**CITY OF LINO LAKES  
PLANNING & ZONING BOARD MEETING**

**PLANNING & ZONING BOARD  
AGENDA ITEM 5A**

REQUEST: **PUBLIC HEARING**  
Century Farm North 7<sup>th</sup> Addition  
1. Preliminary Plat  
2. PUD Final Plan/Final Plat

**Re:** *Century Farms North 7<sup>th</sup> Addition  
Plan Review  
WSB Project No. 2988-200*

JOB NO. 16-129  
 SHEET TITLE  
**STREET PLAN & PROFILE**  
 SHEET NO.  
**C6**  
 SHEET 6 OF 9

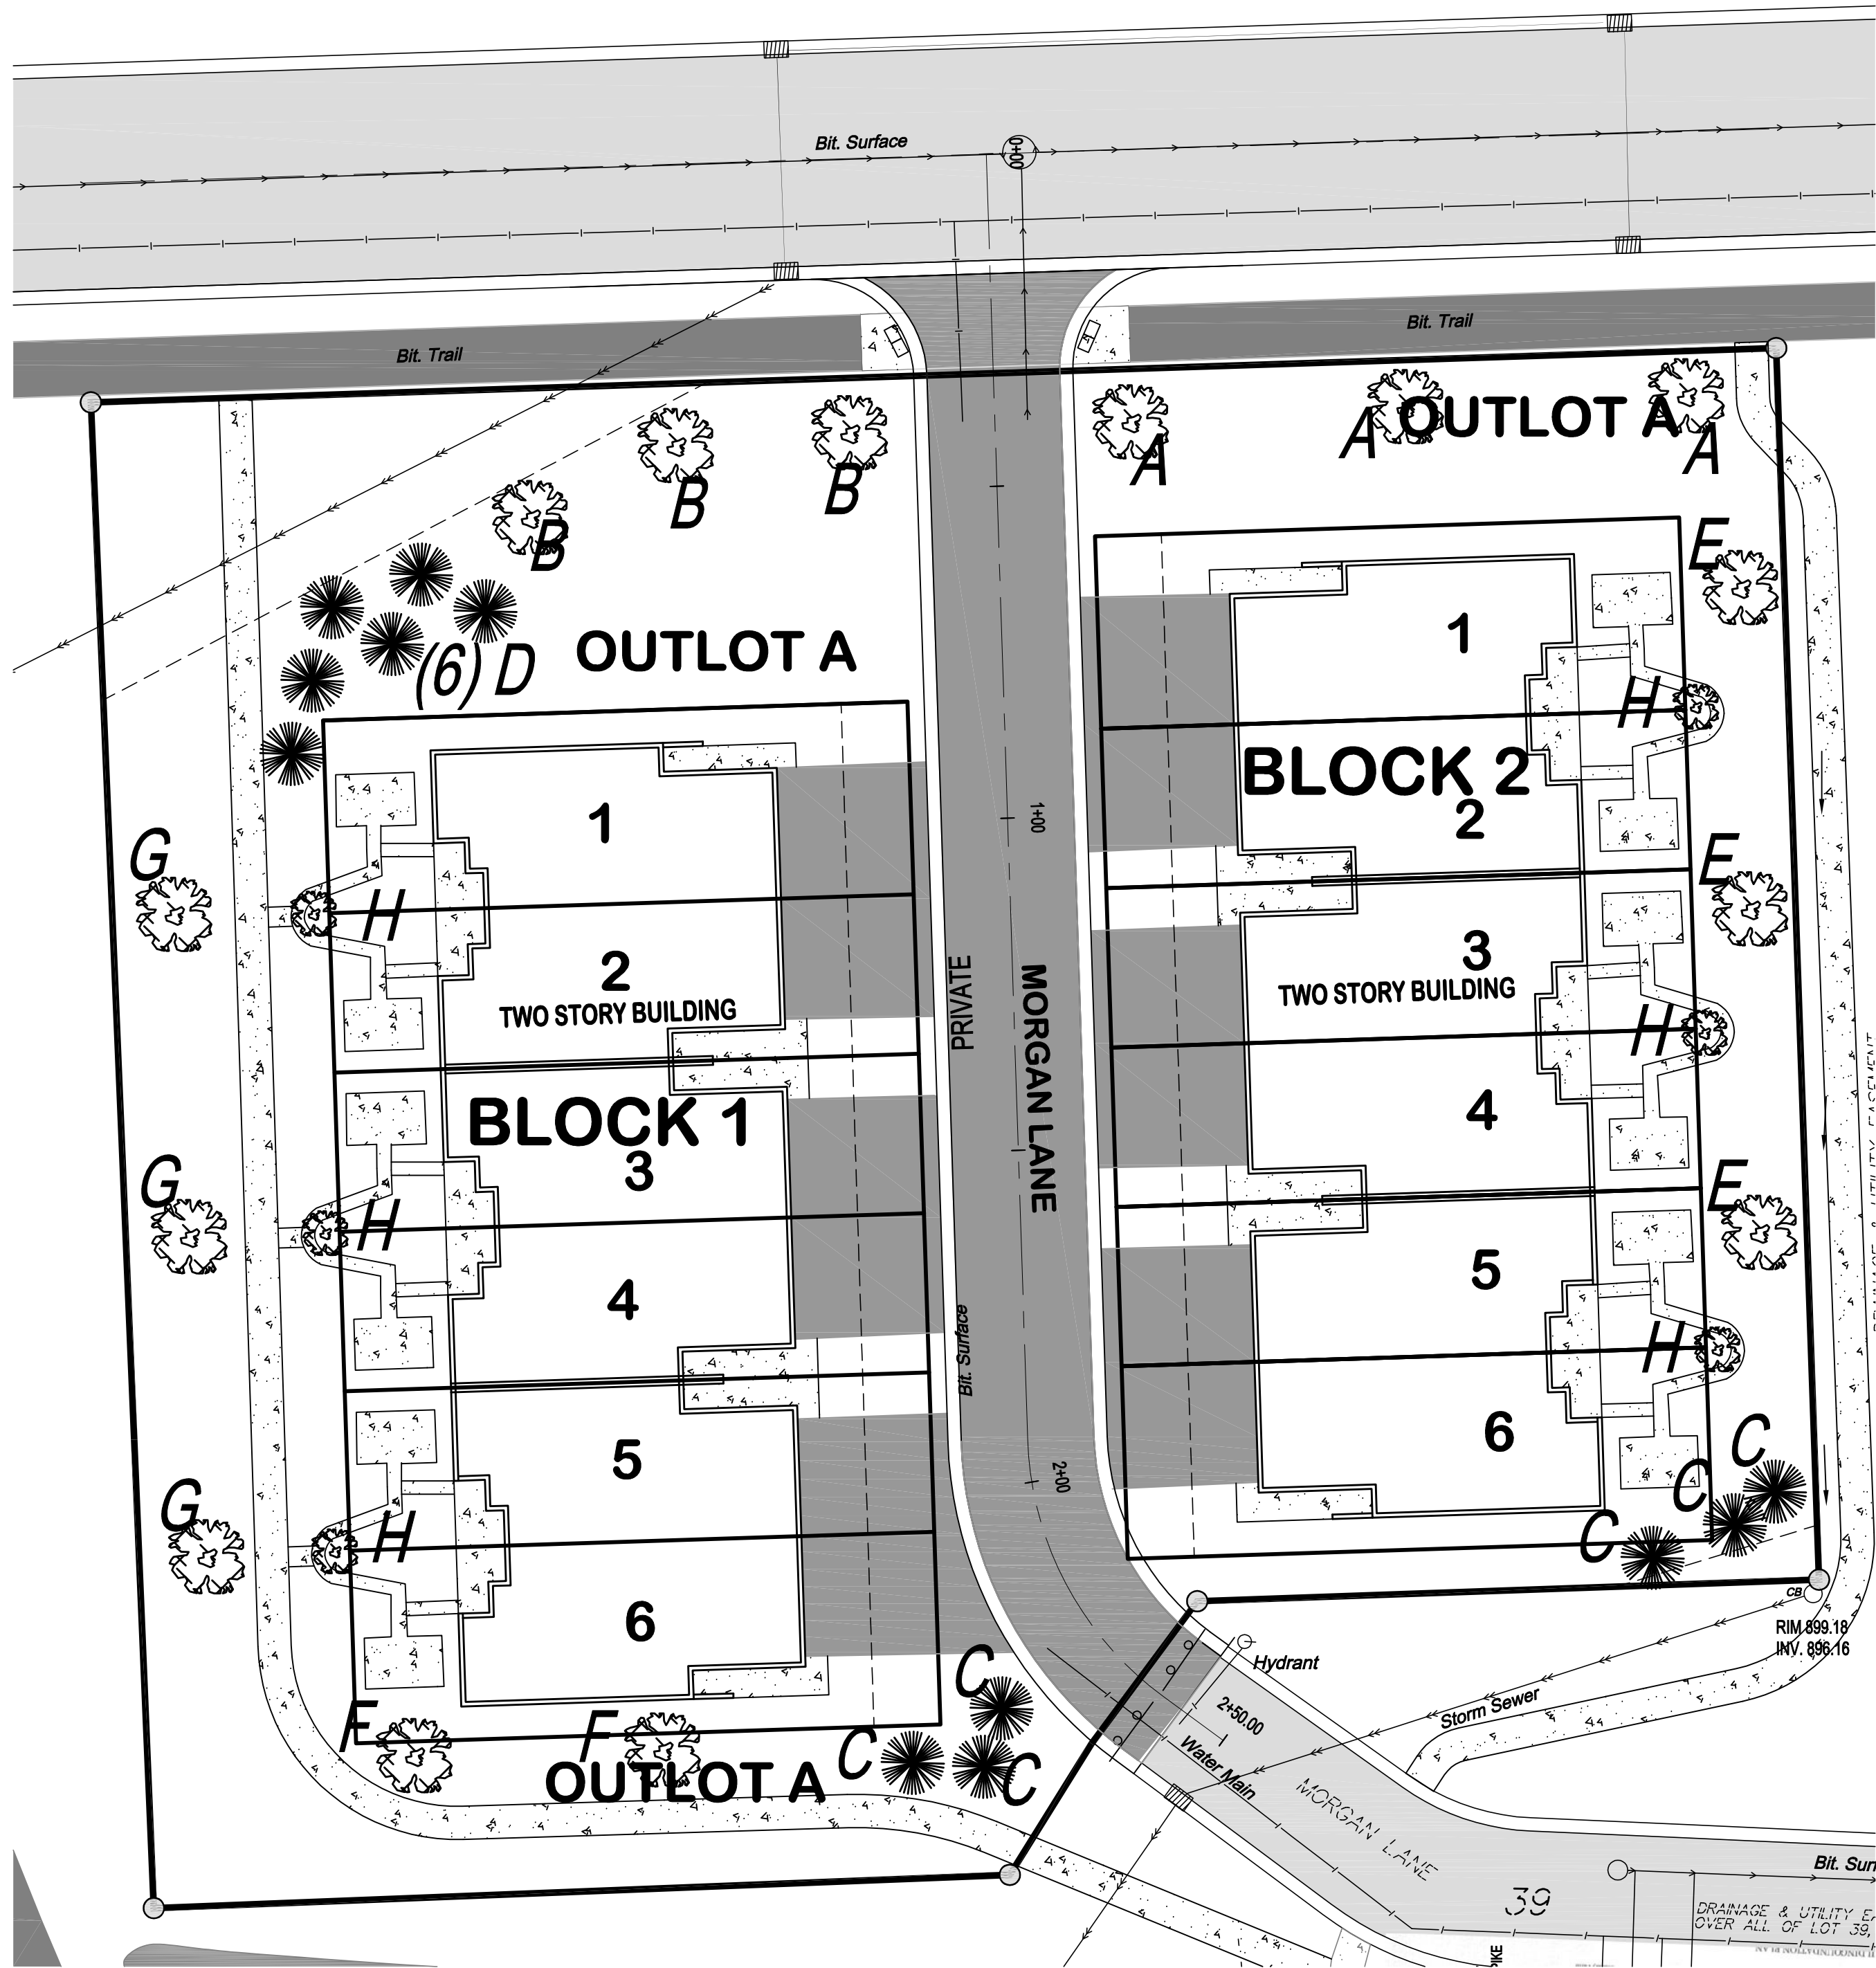
14. Sheet C7, Street Plan & Profile:
  - a. The plan sheet shall be renamed Sanitary Sewer & Watermain Plan.
15. Sheet L1, Landscape Plan:
  - a. Sheet L1, Landscape Plan is not consistent with the approved Master Landscape Plan and shall be revised.

SHEET TITLE  
**LANDSCAPE PLAN**

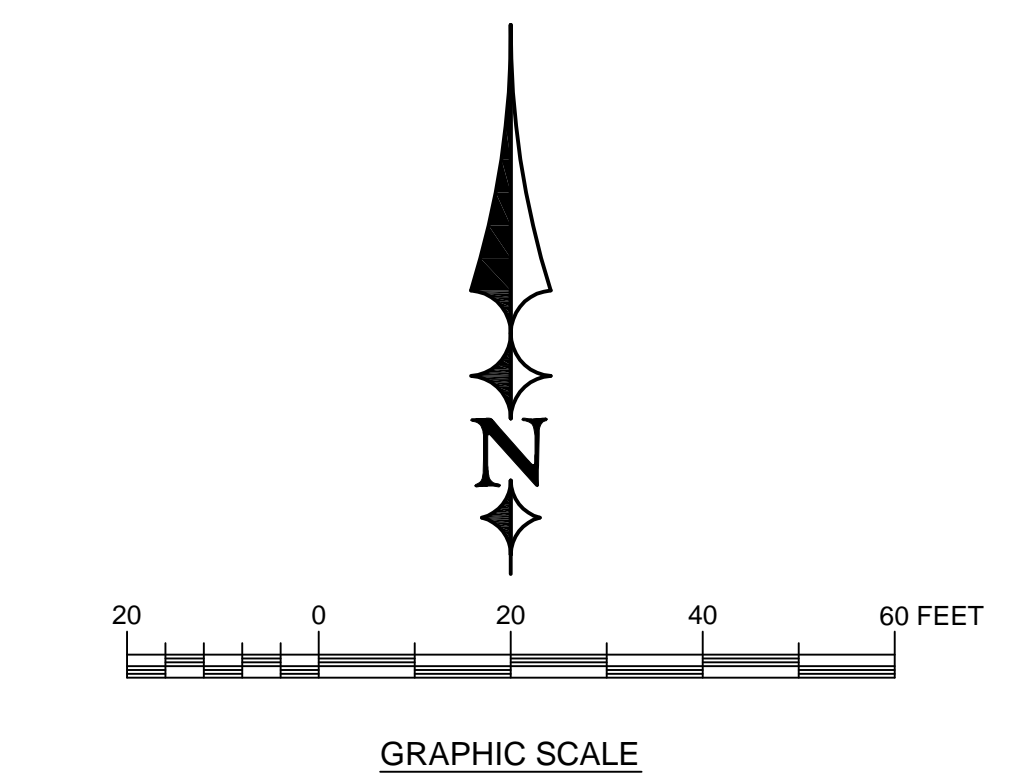
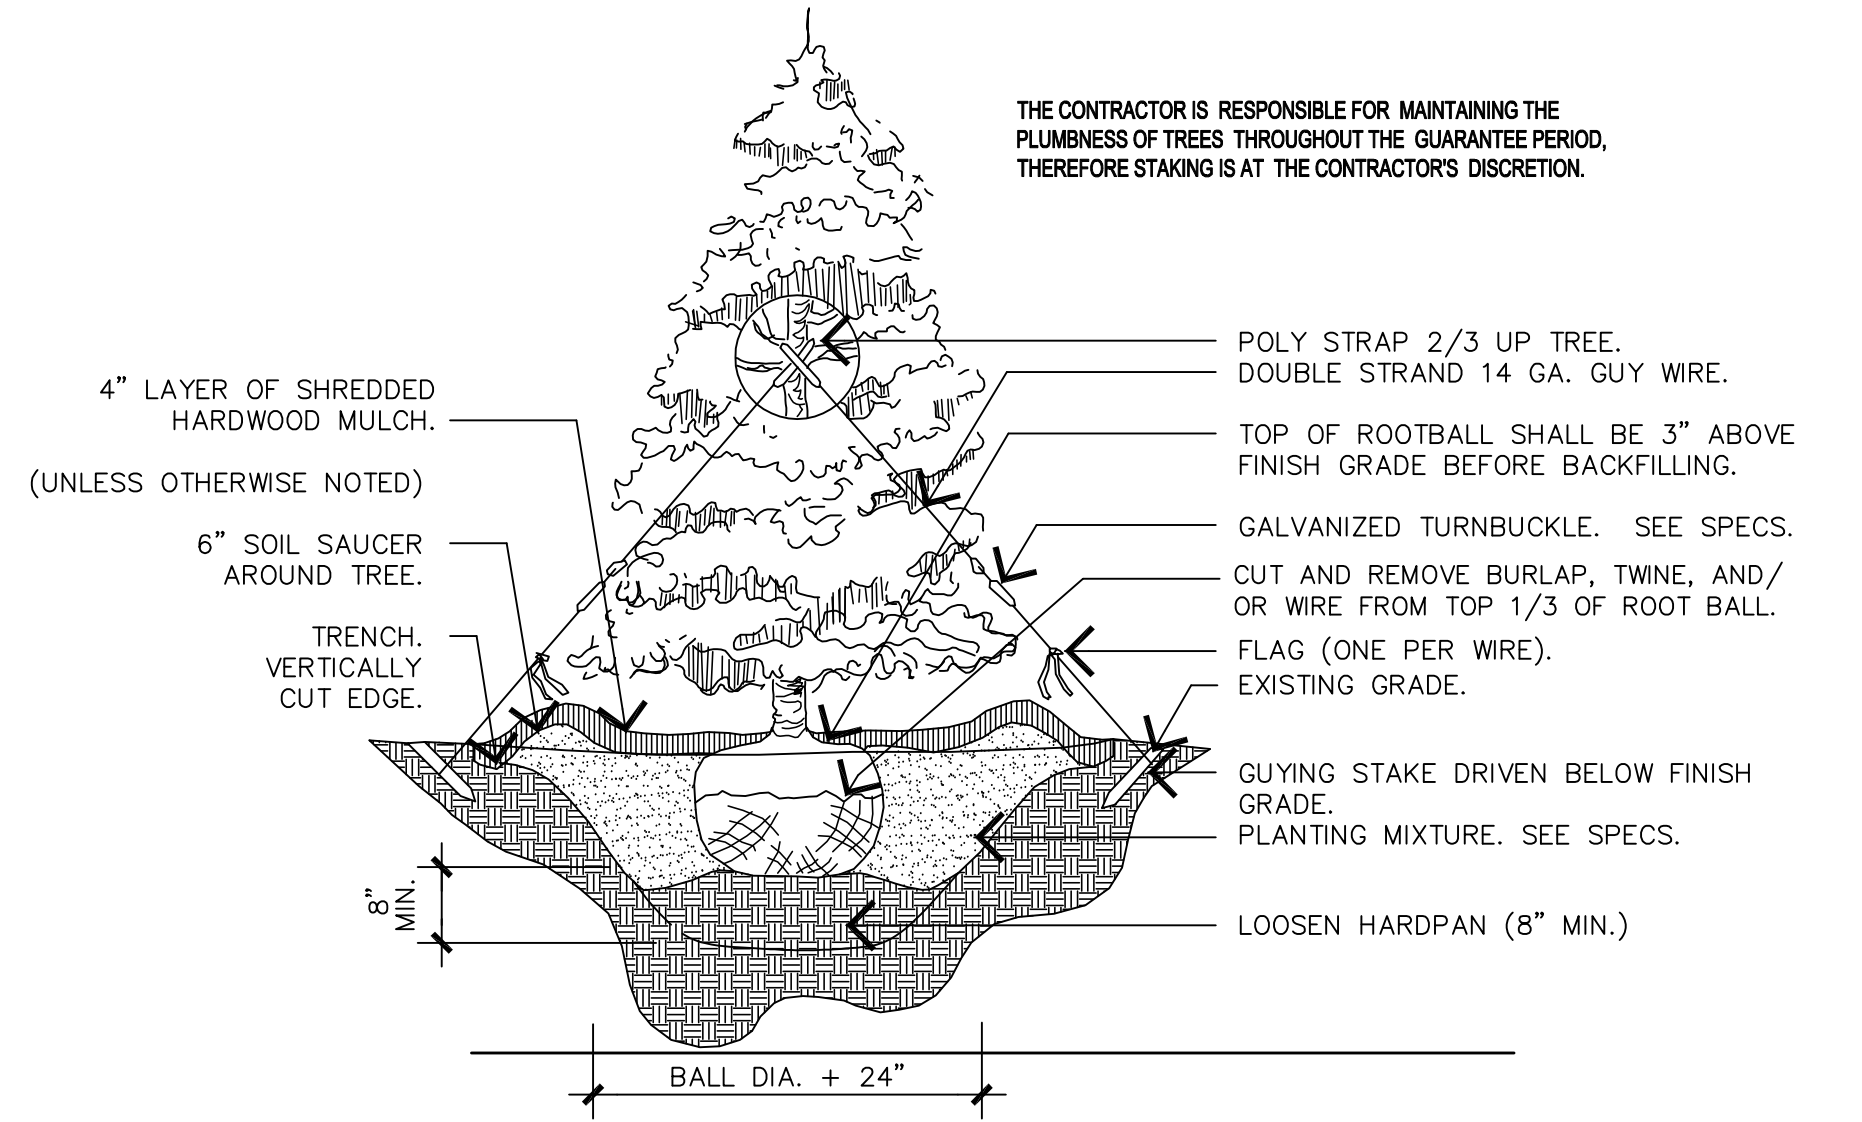
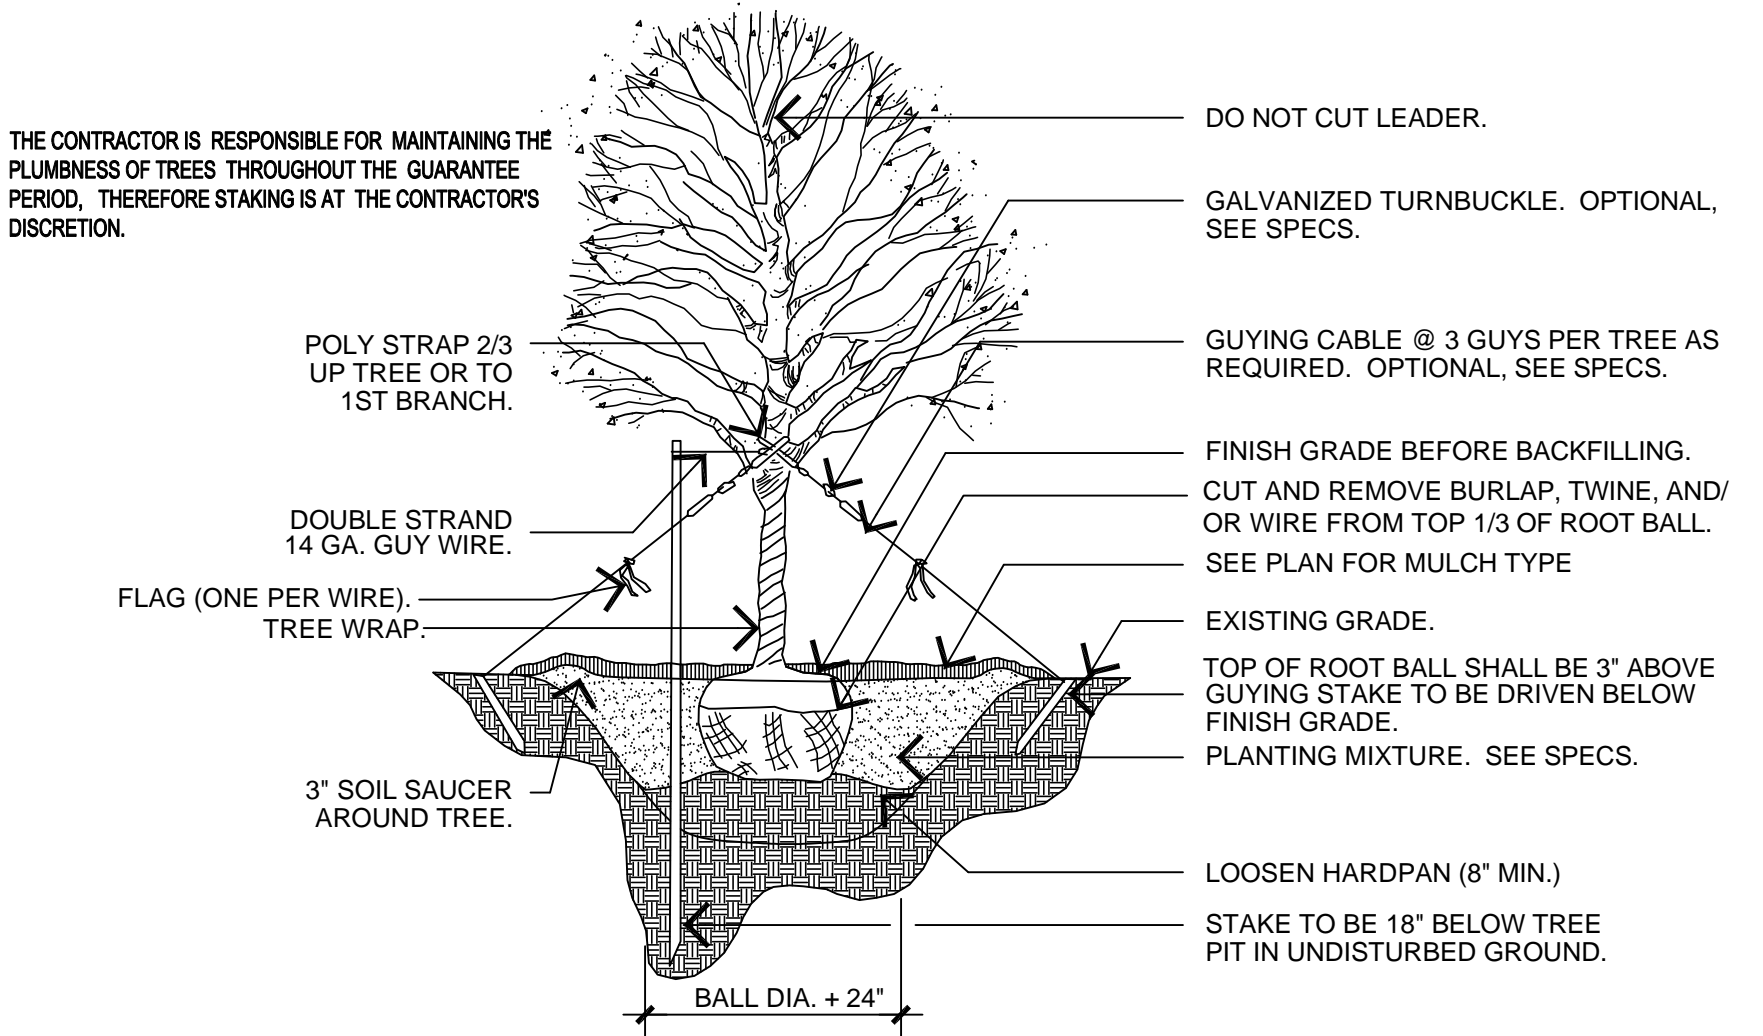
1. Sheet L1, Landscape Plan is not consistent with the approved Master Landscape Plan and shall be revised.
2. Add a note on the Landscape Plan that open area (Outlot A) shall be sodded.
3. An irrigation plan shall be submitted.

- b. Add a note on the Landscape Plan that open area (Outlot A) shall be sodded.
  - c. An irrigation plan shall be submitted.

- In the plant landscape pallet, something else should be used in place of the Showy Mountain Ash because of disease concern
- Irrigation must be required with sodded areas.
